**Assessment of the results of a seismic tomographic survey at
Silbury Hill, Wiltshire.**

**M.H.Worthington
Imperial College Consultants (ICON Ltd)**

For English Heritage

23 January 2002

Figure 1: Plan view of tomographic image with positions of surface geophones (red dots) and boreholes (blue diamonds).

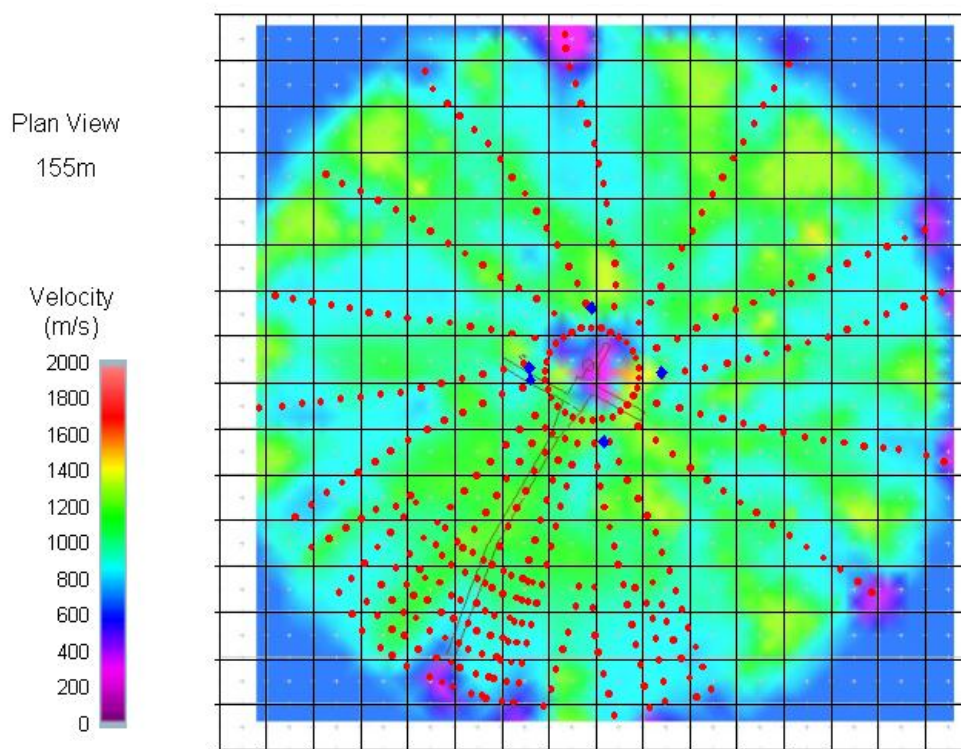
Note that at the outer fringes of the image, there is a correlation between the velocity image and the location of the geophone lines (or spokes as they will be referred to below). This is not at all surprising. Seismic data recorded at the end of the spokes will normally have the lowest S/N ratio. There is a tendency to pick travel times late if S/N ratio is poor because the first arrival can often be small relative to events at later

time. Consequently, I am not surprised to see regions of low apparent velocity at the tips of some of the spokes, particularly as ray coverage at these points is sparse and uni-directional. There is no ray coverage at all between the spokes on the outer fringes of the image. These regions are therefore totally unconstrained by the data and so the petal-like fringe to the image results. However, the low velocity north slope anomaly associated with spoke 19 (see figure 7 for labelling of spokes and borehole) is too large to be dismissed as an image edge artefact.

Figure 3 : Apparent velocities calculated from travel-time picks of the spoke 19 common shot gather with shot at 30 metres depth in hole 2.

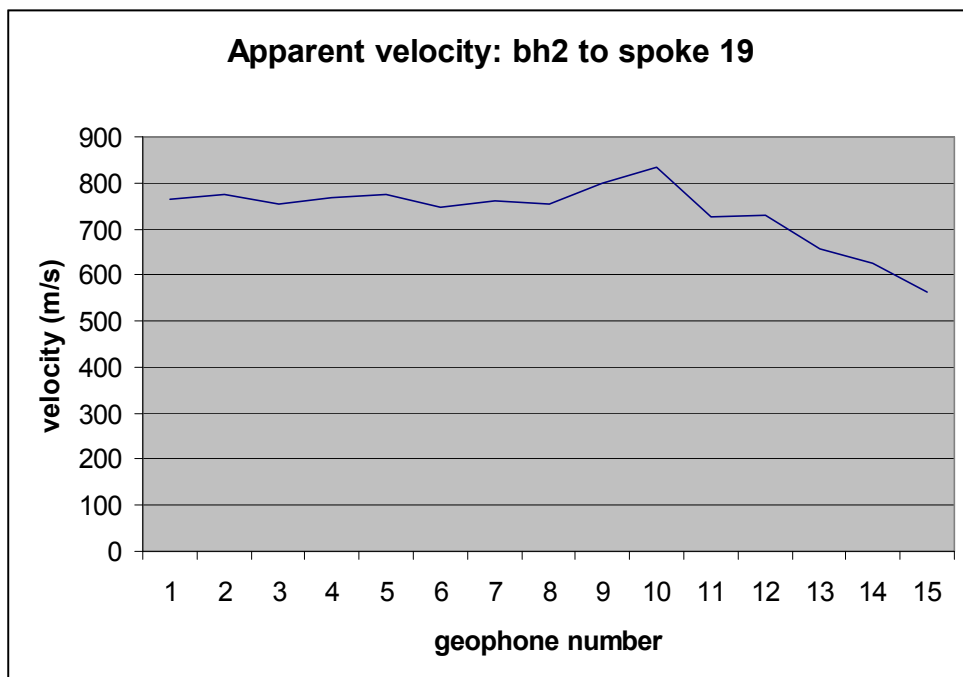
Figure 3 is one result of a simple test to check that a selection of observed travel-times are consistent with the velocity image. It shows the apparent or average velocities calculated from my travel-time picks of the data in figure 4, assuming simple straight ray paths from shot to receiver. I would normally consider traces 11 to 15 to be unpickable. But forcing myself to pick something, I have picked late. The average velocity from the first ten traces is consistent with Skanska's quoted average velocity

for the mound. The onset of lower average velocity or alternatively poor data quality coincides with the location of the low velocity zone. I emphasise that this is only a

simple check. The Stanska inversion takes account of any ray bending and averages the results of a large number of picks. However, the comparison of travel-time residual (or apparent velocity) plots with the final image is a standard procedure and is a good rough check on the validity of the result.

This exercise is a good illustration of a common cause of ambiguity. A region of uncompacted ground will normally have a relatively low seismic velocity but is also likely to have a high seismic attenuation coefficient. Consequently, it is difficult to accurately image the low velocity zone because the data quality is poor, precisely because the rays are passing through an uncompacted zone. So I am persuaded of the existence of the north slope anomaly as much by the quite clear evidence of a localised region resulting in poor data quality as I am by the actual value of velocity in the final image. There remains the possibility that the poor data quality is simply due to poor geophone coupling. Alternatively, the low velocity anomaly could be an artifact resulting from the difficulty of picking noisy data but that the data are noisy because of seismic scattering due, simply as a wild guess, to the abundance of flint boulders in the mound in this region. I conclude that further experimentation is required to confirm the existence of a zone on the north slope that is cause for concern. Fortunately, the obvious additional experiments are simple and relatively inexpensive. I would recommend a simple surface refraction (time-term) survey up the slope in the vicinity of spoke 19 and at one or more other radial positions for comparison.

Figure 4 : Common shot gather from a shot at 30 metres depth in hole 2 into spoke 19.

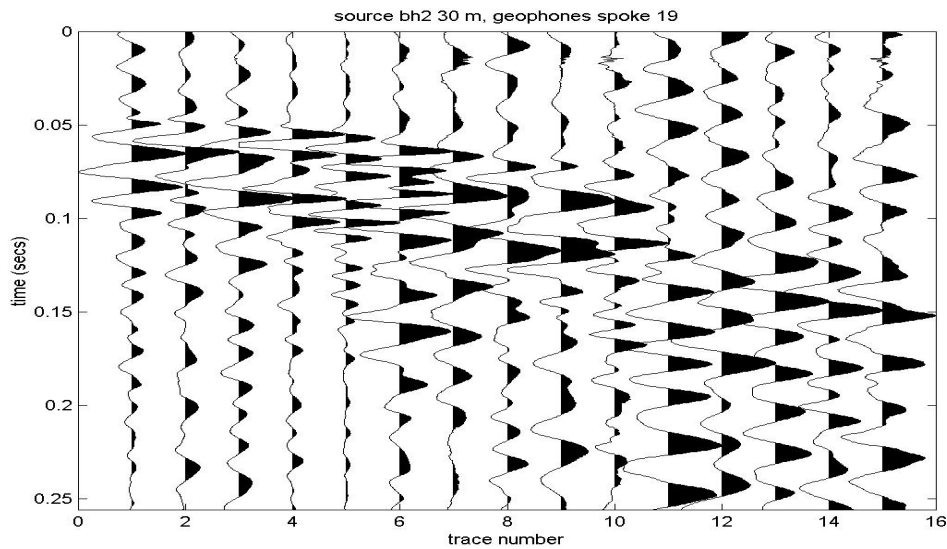
Figure 4 shows a common shot gather from a shot at 30 metres depth in hole 2 into the geophones of spoke 19. Note how the data quality (S/N ratio) reduces rather abruptly at and beyond geophone position 11. This effect is generally observable in all spoke 19 gathers. Figure 5 shows another example for a shot in hole 1. Here the relatively abrupt transition in data quality occurs at geophone position 13. For comparison, I also have included (figure 6) the gather from a shot at 30 metres depth in hole 2 into spoke 25. Note the good data quality for all traces compared to the outer traces of figure 4.

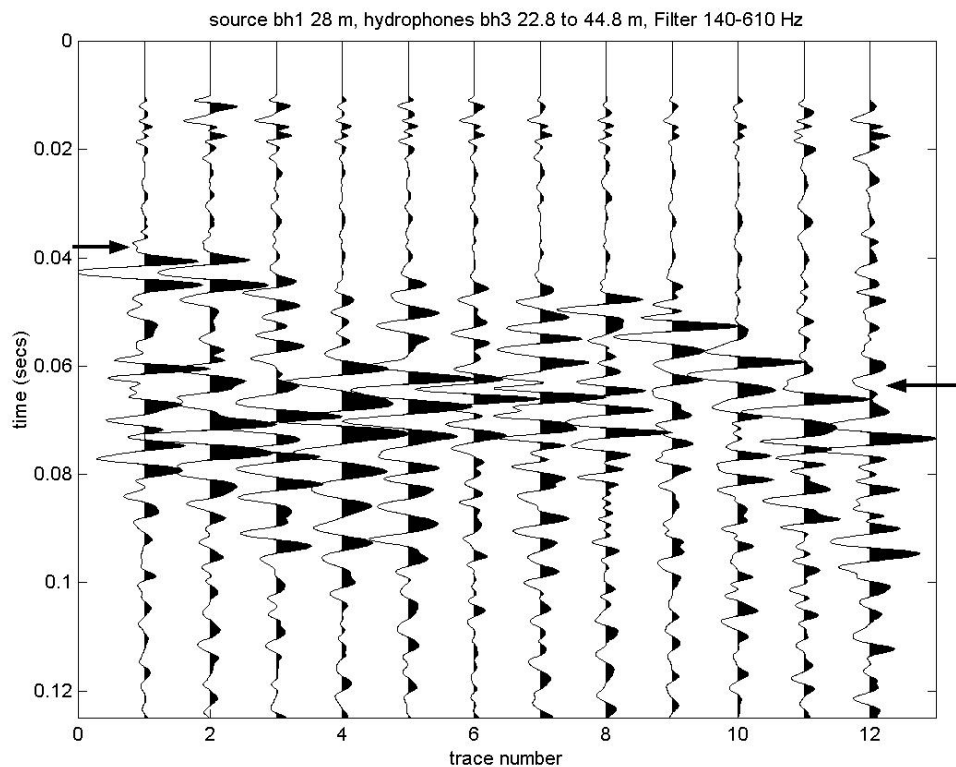
interpretable hydrophone data. Picked times were identified and the time increased from trace 1 to trace 12. The two arrows in figure 9 mark the approximate beginning and end time of these picks.

A similar event to the one shown in figure 9 is recorded for shots at 26, 30, 32 and 34 metres depth. Above and below this depth, the event disappears and no evidence of

any event that might have been generated by the shot can be identified. This is worrying. The fact that no other similar high frequency, high quality event could be identified in any of the other 201 hydrophone shot gathers is reason for caution. One might reasonably expect the minimum travel time to appear opposite the source depth at 28 metres which corresponds to trace 4, rather than at trace 1. In addition, the form of the event (relative travel times from trace to trace and shape of the waveforms) is similar for the five shot gathers. However, there is a mean travel-time difference for the different shot gathers. This is illustrated in figure 10. Common receiver gathers are shown for hydrophones at 22.8, 32.8 and 40.8 metres depth. Note that the five signals in any one receiver gather are approximately similar. Note also that the relative time shift between traces in a gather is the same for all three gathers.

Figure 10 : Common receiver gathers for shots at depths 26, 28, 30, 32 and 34 metres depth in hole 1 recorded by hydrophones in hole 3 at depths, A: 22.8 metres B: 32.8 metres C: 40.8 metres.

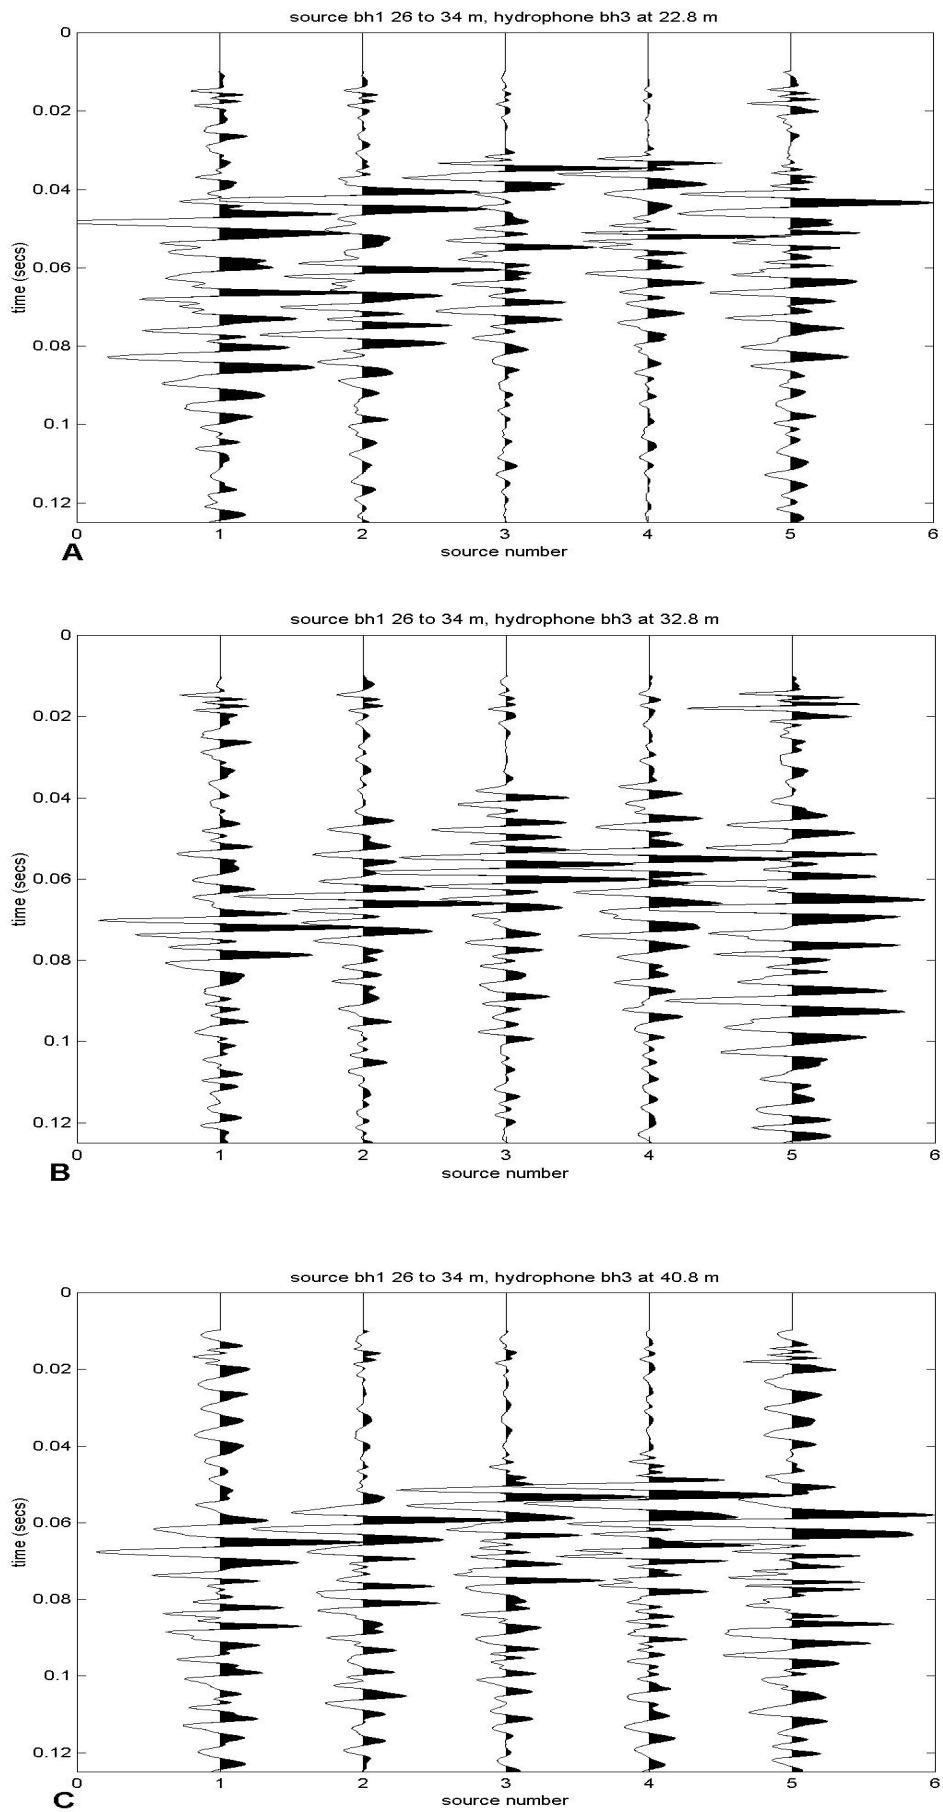
These data cannot be explained in terms of the travel-times one might reasonably expect between parallel shots and receivers. Essentially, we have five recordings of approximately the same event, differing only by a static time shift. It would be attractive to postulate that it is secondary scattered energy from some point diffractor and the time shift represents the travel-time from source to diffractor. Unfortunately, I fail to envisage any configuration of shot, diffractor and receiver array that would result in the travel-time shifts shown in figure 10. I can think of only two possible explanations:

- (1) It is a spurious noise event that happens by chance to have been caught in the recording time window. Alternatively, the noise event might have something to do with the shot but the time delay between shot and noise event is random.
- (2) A diffracted event is directly causally connected to the shot but the seismograph trigger is operating erratically.

I am not particularly satisfied with either of these explanations. I can only add that I have been doing crosshole surveys using hydrophone strings for over twenty years and this is not the first time I have puzzled about and failed to understand the cause of spurious events. However, I am completely certain that travel times from these five hydrophone gathers should not be included in the tomography data.

I conclude that there is no evidence at all for a low velocity anomaly towards the bottom of the central core of the mound between the boreholes. This region can only be investigated by attempting another crosshole survey, having established the cause of the failure of the previous survey.
